SYDNEY WEST PLANNING PANEL

Panel Reference	2019WCI034
DA Number	DA0036/19
LGA	Hawkesbury City Council
Proposed Development	Waste management facility - Construction and material crushing and recycling plant processing facility.
Street Address	100 Fairey Road South Windsor
Applicant/Owner	Andrew Irwin
Date of DA lodgement	7 February 2019
Number of Unique Objections	<ul style="list-style-type: none"> 6
Recommendation	Refusal
Regional Development Criteria (Schedule 7 of the SEPP (State and Regional Development) 2011)	<p>Schedule 7 Regionally significant development</p> <p>7 Particular Designated development Clause 7:</p> <p>Development for the purposes of:</p> <p>(c) waste management facilities or works, which meet the requirements for designated development under clause 32 of Schedule 3 to the Environmental Planning and Assessment Regulation 2000.</p>
List of all relevant s4.15(1)(a) matters	<ul style="list-style-type: none"> Environmental Planning and Assessment Regulation 2000 Clause 32 State Environmental Planning Policy (State and Regional Development) 2011 State Environmental Planning Policy No. 55 (Remediation of Land) SEPP (Infrastructure) 2007 Deemed State Environmental Plann

Figure 5: Earthworks Schematic extract

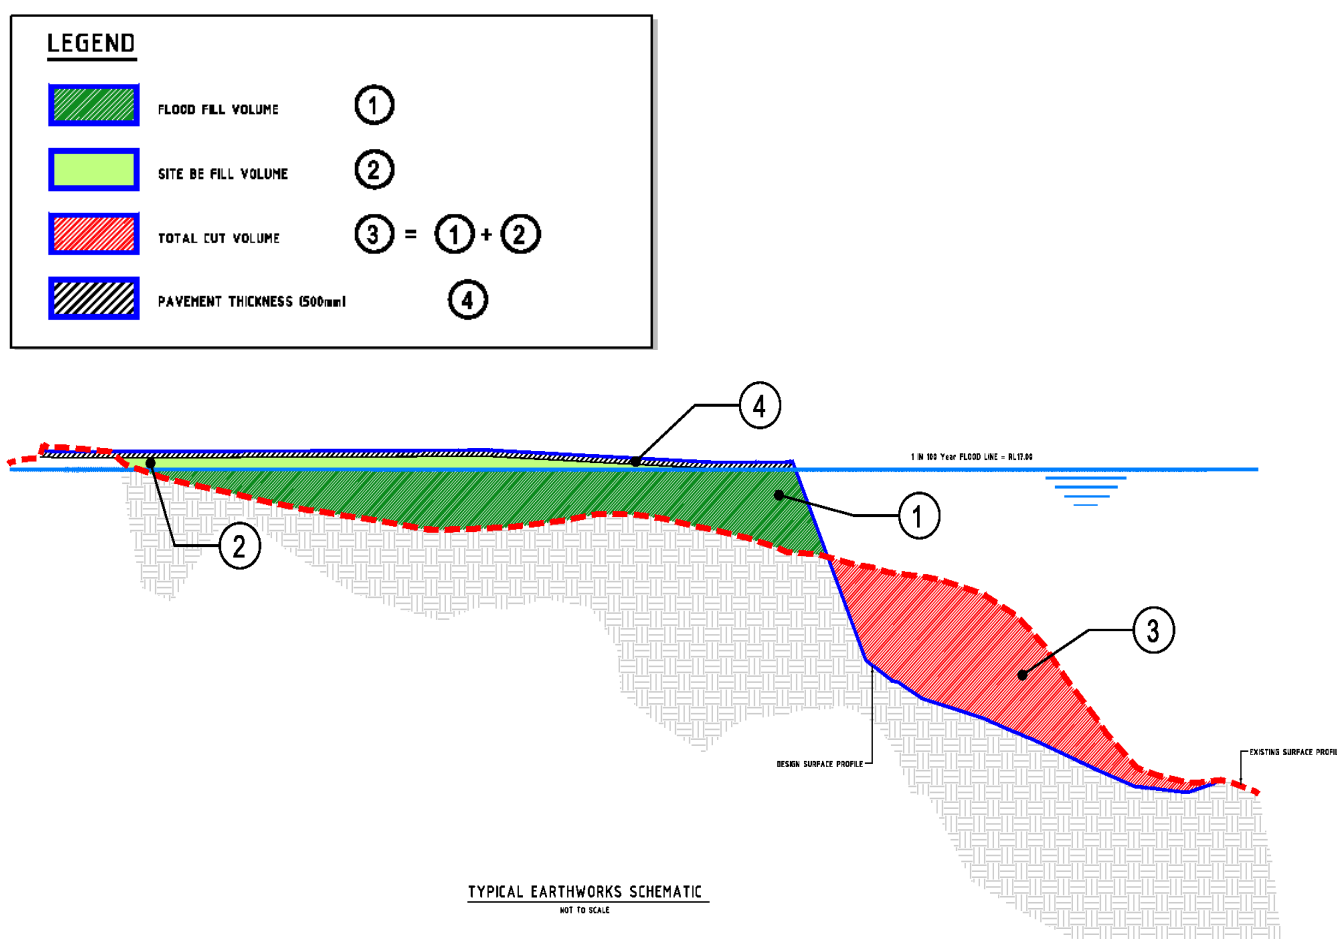
Whilst the application has provided assessments on the matters listed in (a) and (b), the application has failed to carry out an assessment of the matters listed in (c) and (d). The resulting landform from the extraction of soil to provide the leveled platform has not been adequately addressed in terms of site management and usability. Revegetation has been proposed as a management strategy for the earthworks, however excavation of up to 5m is proposed and whilst erosion and sediment control measures to manage runoff to the watercourse have been proposed, this does not address the short and long term soil erosion issue that will occur from the earthworks whilst the site is being revegetated. It has also not been demonstrated that the revegetation proposed will address the stability of the final landform, particularly when the resulting landform has been presented in the following earthwork schematic in the following Figure 5.

Figure 6: Location of coastal wetlands and proximity area

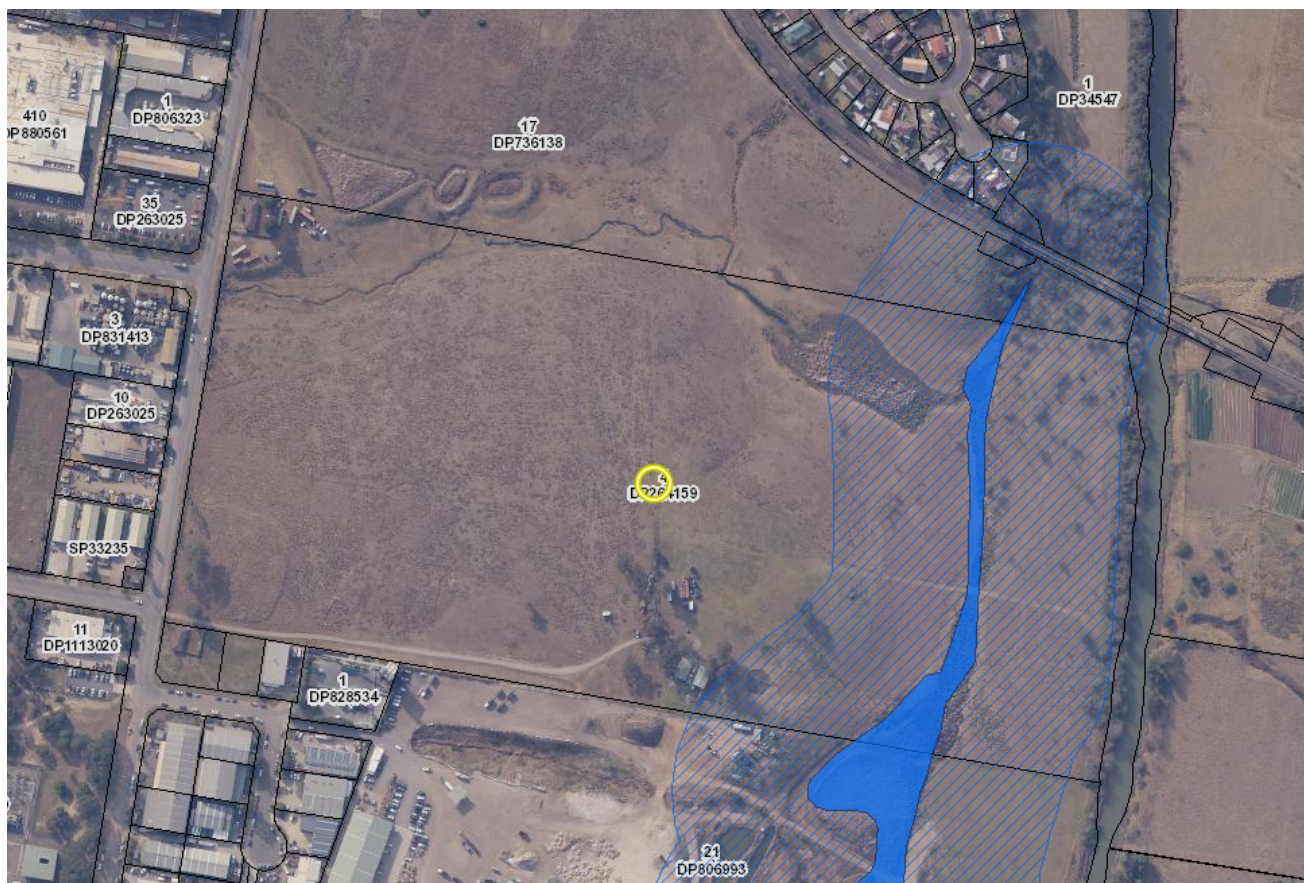
The site is mapped as Coastal Wetlands, Coastal Environmental Area and Coastal Use Area for which Division 1 Clauses 10 and 11, Division 3 Clause 13 and Division 4 Clause 14 are required to be considered. The proposed development does not encroach into the Coastal Wetlands, Coastal Environmental Area and Coastal Use Area, however the earthworks do encroach into the proximity area for coastal wetlands, as highlighted in hatched blue in Figure 6 below.

The plans have not clearly identified the extent of earthworks into the proximity area. Whilst the earthworks have remained outside the 40m buffer zone from the wetland, the earthworks will encroach into the proximity area. This level of cut will fundamentally change the landform and topography of the site and the impact on the proximity area has not been considered in the application.
